Application Name: Eastern Northants Management Facility Western Extension

Application Ref: WS010005

East Northants Resource Management Facility Western Extension

Anglian Water – written summary of oral contribution on 8 June 2022 (ISH3)

Route 2

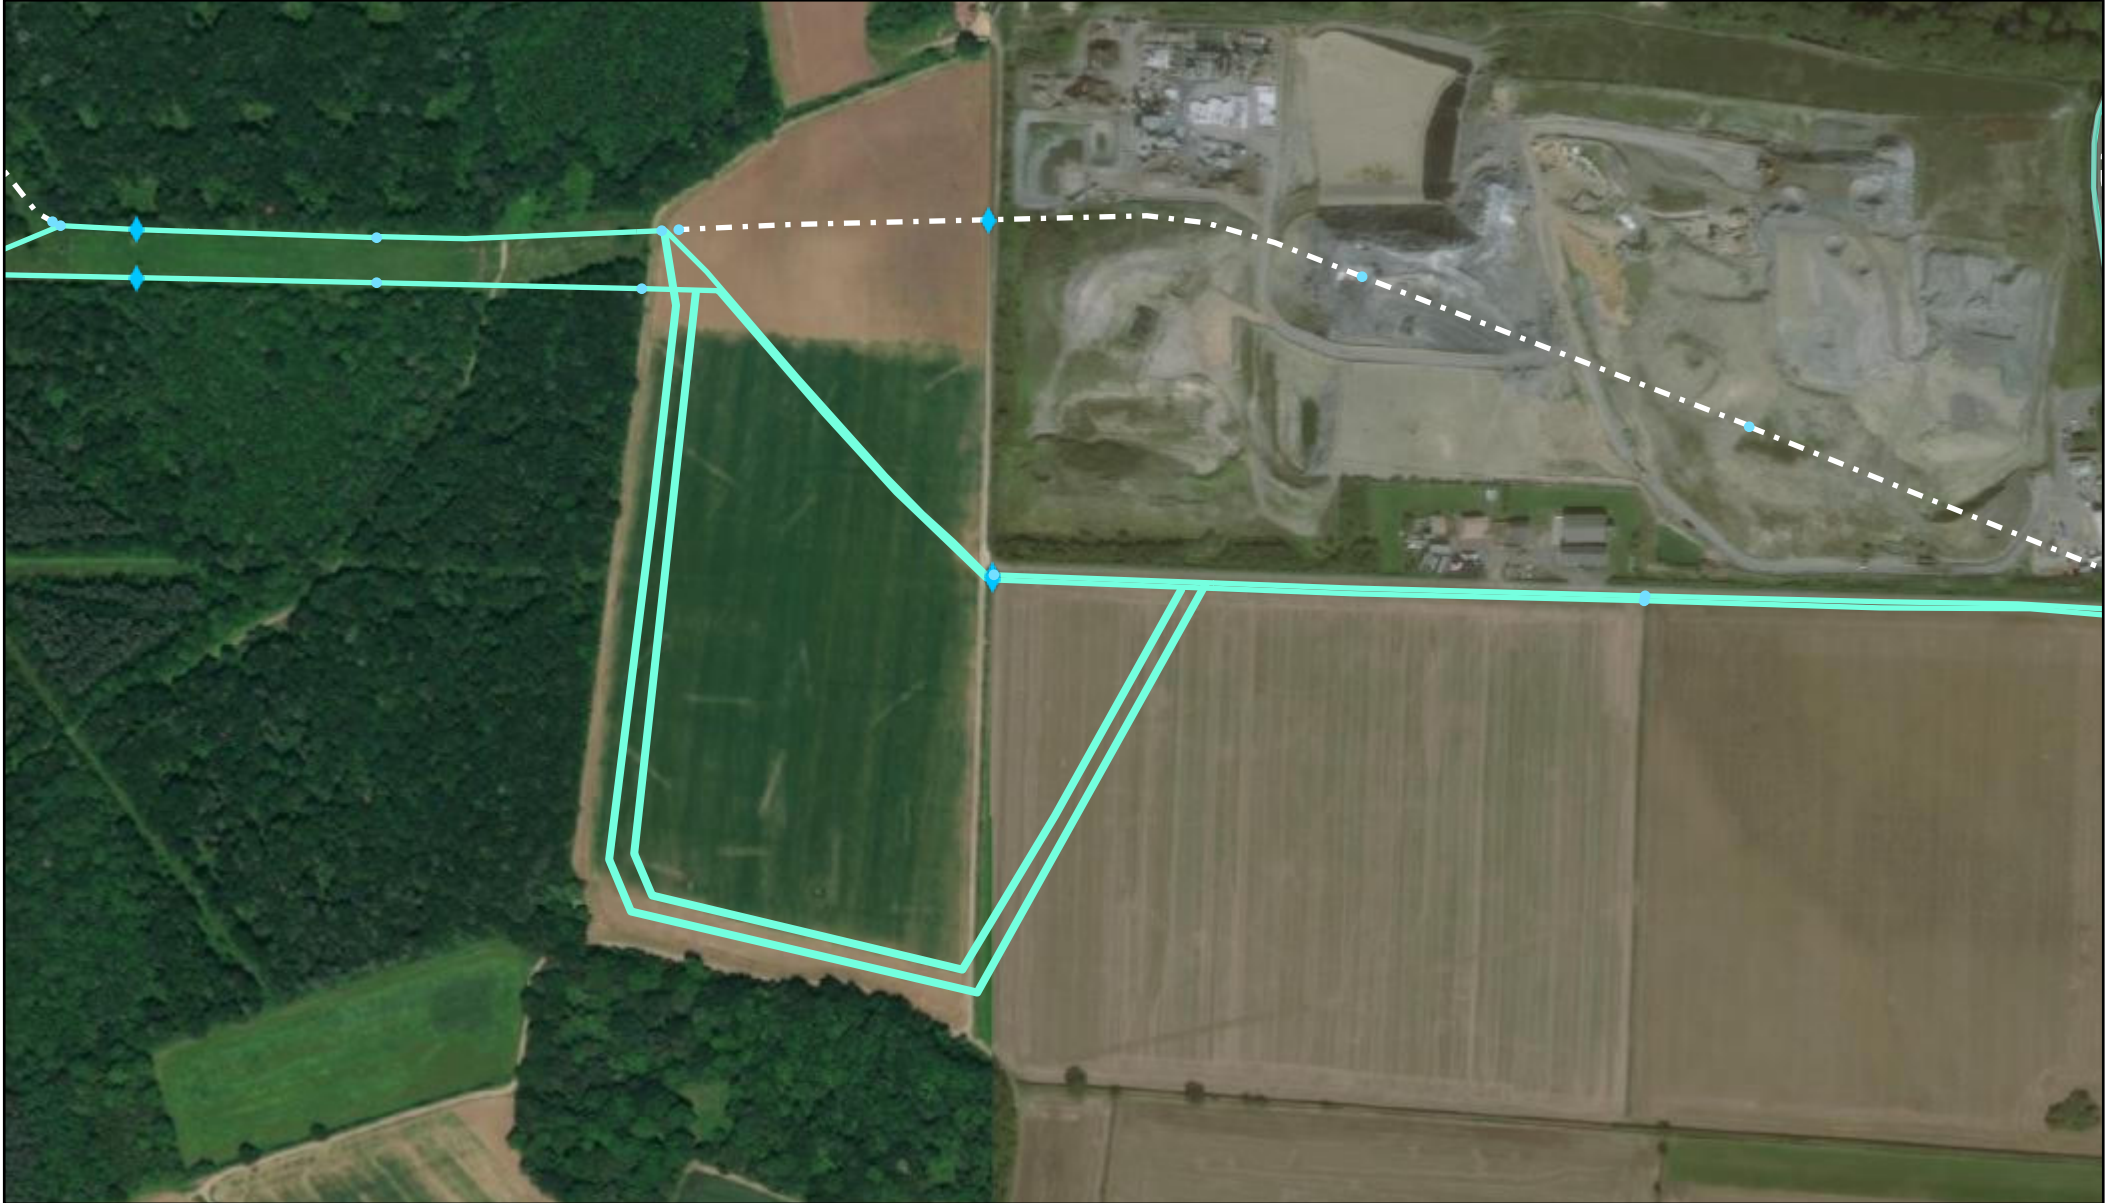
Route 2: a shorter version of the above, introducing more 90-degree bends in the system which would need further consideration/assessment.
